ILLINOIS POWER COMPANY

Subject: Clinton Power Station Unit 1
Request for Additional Information Concerning the
Safety Parameter Display System for Clinton Power Station

Response to Request for Additional Information Concerning
the Clinton 1 Safety Parameter Display System

Diagram of Online Monitoring of Isolators

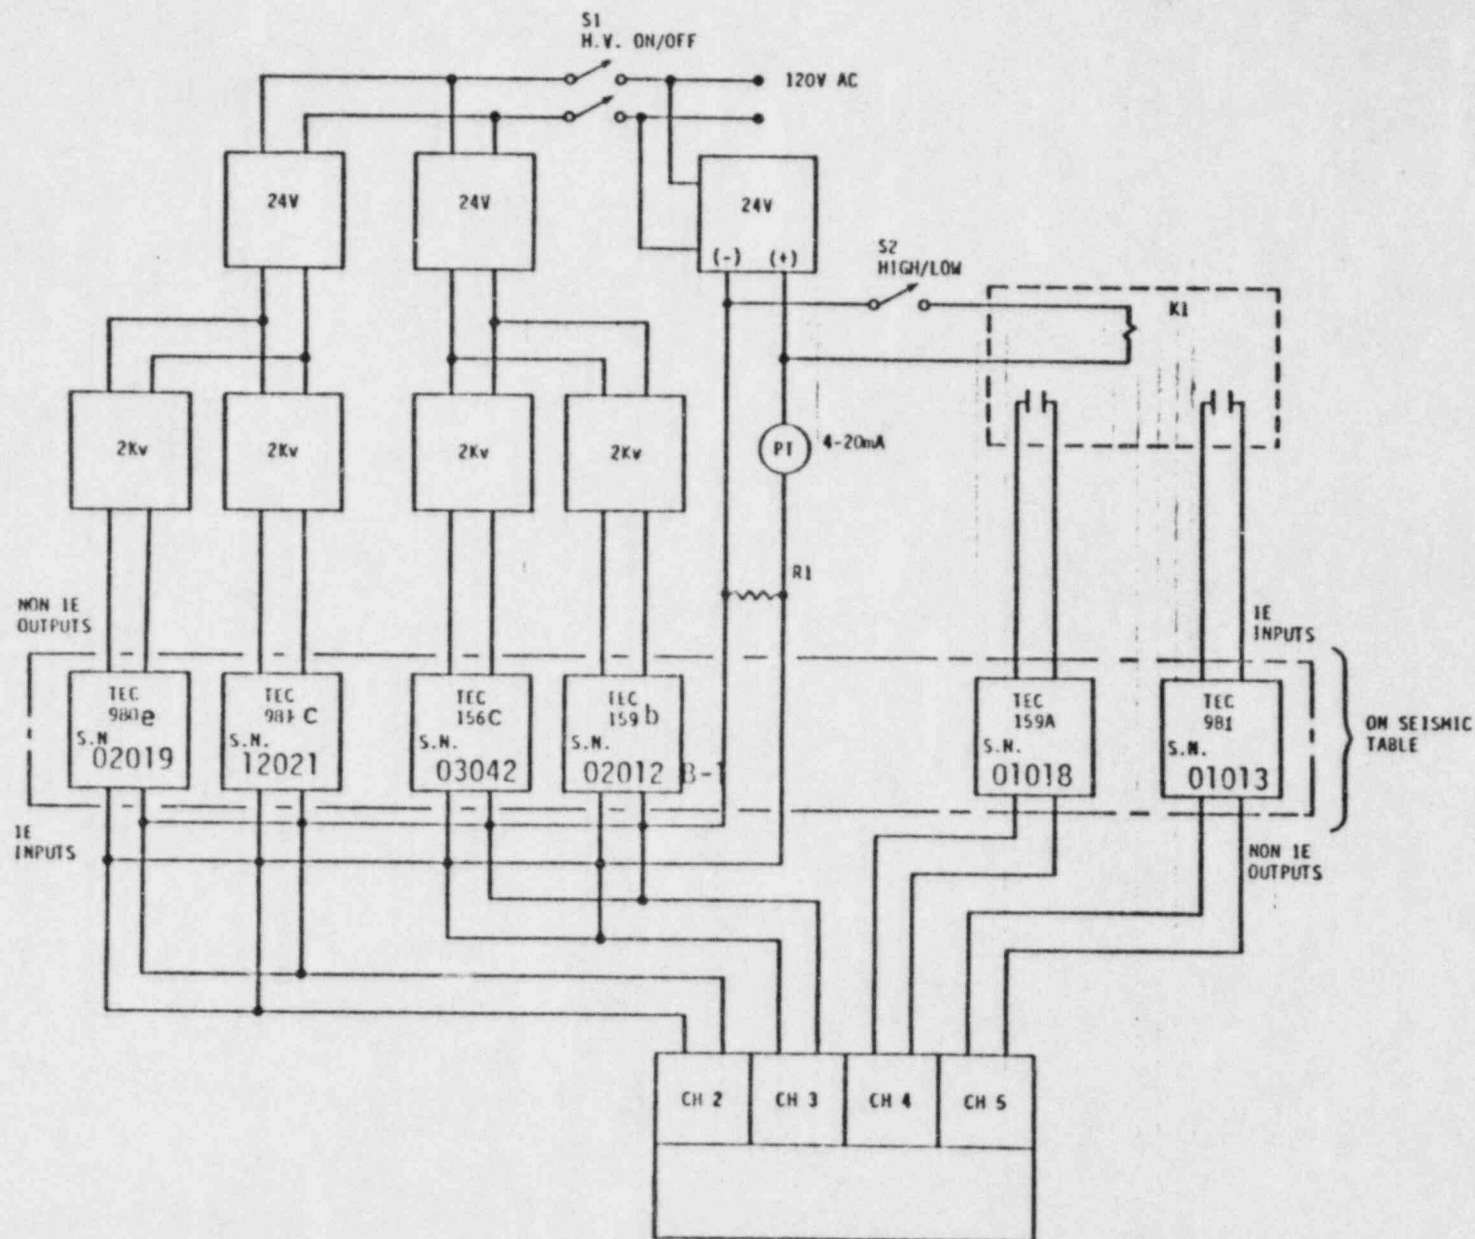
Data to verify the maximum credible faults applied during the test were the maximum voltage/current to which the device could be exposed, and define how the maximum voltage/current was determined.

Data to verify that the maximum credible fault was applied to the output of the device in the transverse mode (between signal and return) and other faults were considered (i.e., open and short circuits).

Define the pass/fail acceptance criteria for each type of device.

As a qualification criteria, the maximum creditable fault or worst case Design Basis Accident was established as 2000 Vdc applied across the non-1E outputs of the analog and digital isolators during the SSE tests. The 1E input-side of the isolators was monitored to see that no breakdown in isolation had occurred. The maximum creditable fault current applied is that current resulting from the 2000 Vdc.

The worst-case Design Basis Accident (DBA) postulated for the TEC isolators was verified when 2000 Vdc was applied between the non-1E and 1E outputs during the SSE test. The 1E input-side of the isolators were monitored to see that no breakdown had occurred. The TEC Model 159 power supply and Model 981 digital isolators were functionally tested for high and low output during the second SSE.

A Honeywell absolute pressure transmitter was placed in operation as the analog input to analog isolators, and the 1E inputs were recorded by a strip chart recorder. During the seismic event, 2000 Vdc was applied continuously to the outputs of the isolators; no transients were recorded on the 1E input line, nor was there any damage to the input or recording electronics. See Attachment 1 for a diagram of the test setup.

FIGURE 13.5-1

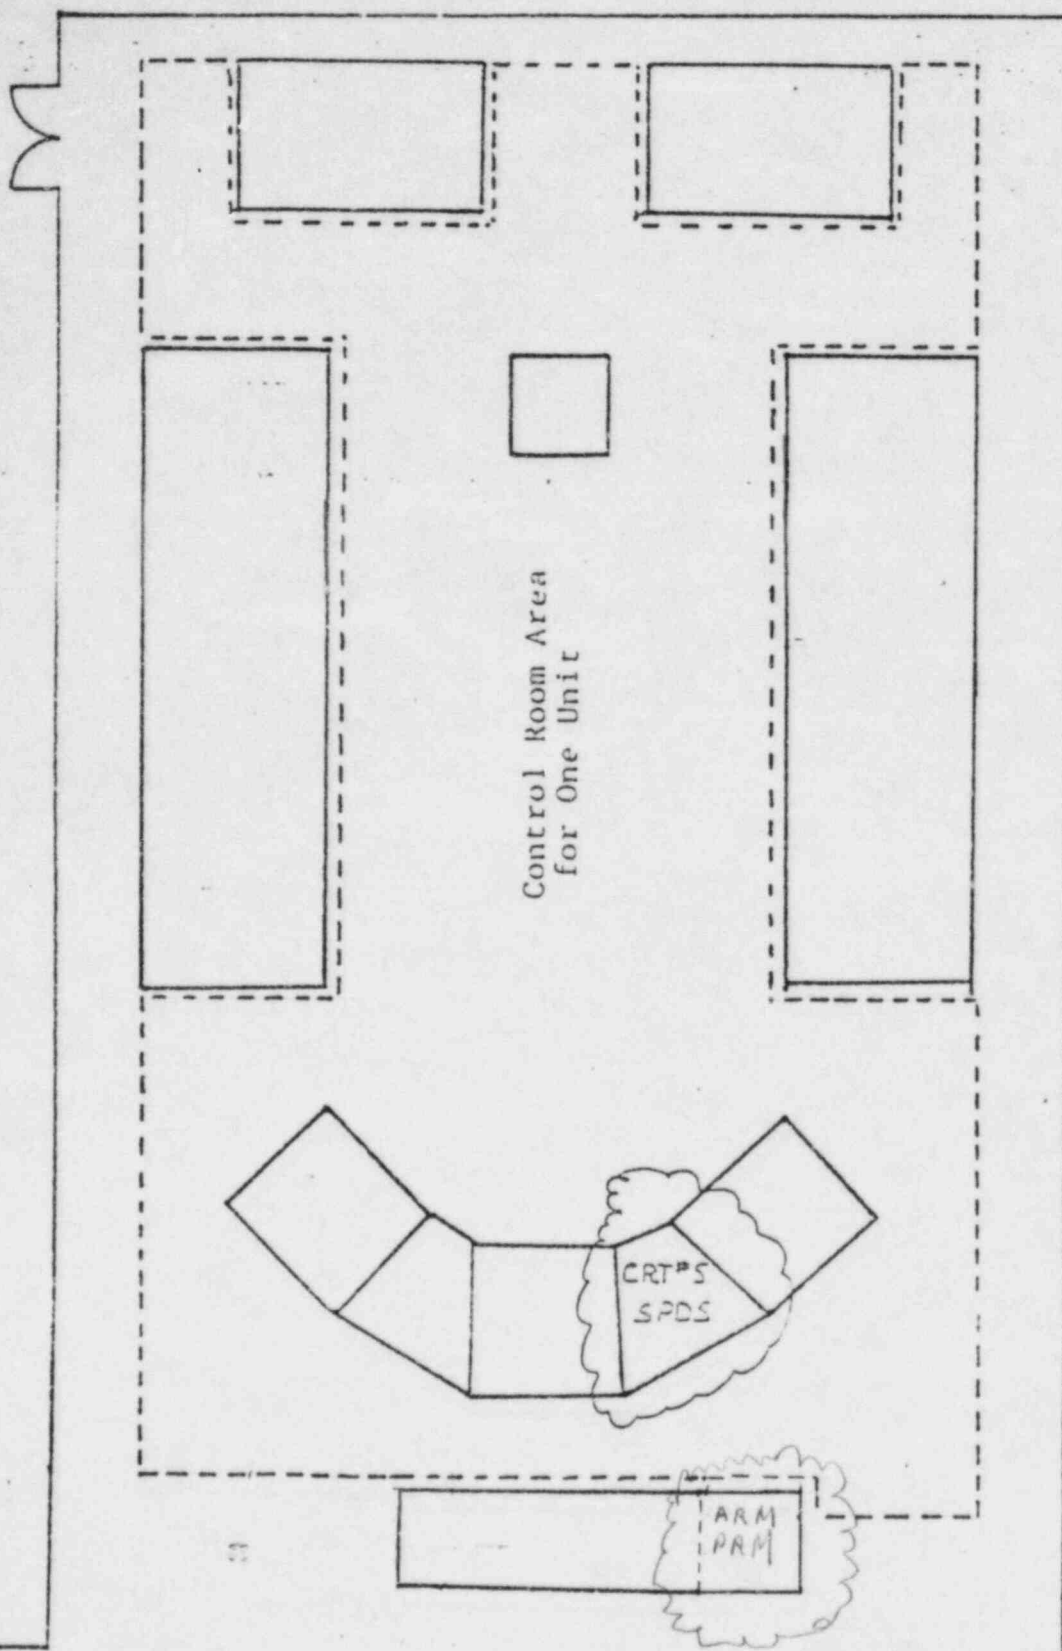
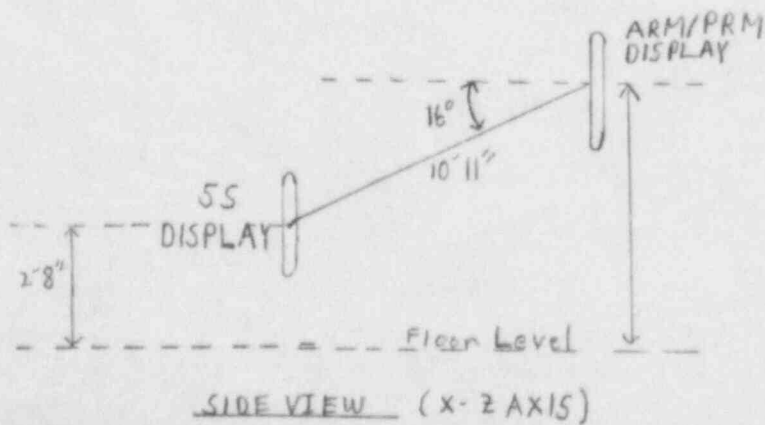
1. Provide an explanation why the inconsistent use of color code meanings will not mislead the operator; that is, since yellow denotes "normal" on the primary SPDS display but denotes "abnormal" or "trending high" on the ARM/PRM, there seems to be a risk of the operator misinterpreting a yellow data point as being "normal" on the ARM/PRM portion of the SPDS when it is actually trending high.
2. Provide discussion/analysis explaining why control of the ARM/PRM displays from the primary SPDS area is unnecessary. The discussion should address the situation in which the ARM/PRM has been switched to a lower level display rather than the "status grid display" and has been left in that condition.
3. Provide a diagram of the control room showing the primary SPDS display location, the ARM/PRM location, the distance between the two locations, and the viewing angle.

Figure 13.5-1 of the CPS FSAR (Attachment #3) has been marked to show the primary SPDS location and the ARM/PRM location. Attachments #4, 5, and 6 show the viewing angles and distances between the displays and the operators.

It should be noted that the final location of the ARM/PRM panel is just to the left of Panel P678, "The Standby Information Panel". This was always to be the permanently installed location for this panel. The ARM/PRM panel was noted as being on the right-hand side of P678 in previous submittals. This location was only temporary. Due to restrictions associated with Fire Protection cable routing, the ARM/PRM panel cannot be installed on the right-hand side of P678. However, it should be noted that, as indicated by the attached sketches, the ARM/PRM panel is more readily visible to the operator from his normal work station (directly in front of the NUCLENET console) if this panel is located to the left of P678. From a human factors standpoint, this location is considered most acceptable, since the operator is not required to rotate his head away from the primary SPDS display in order to view the ARM/PRM panel.
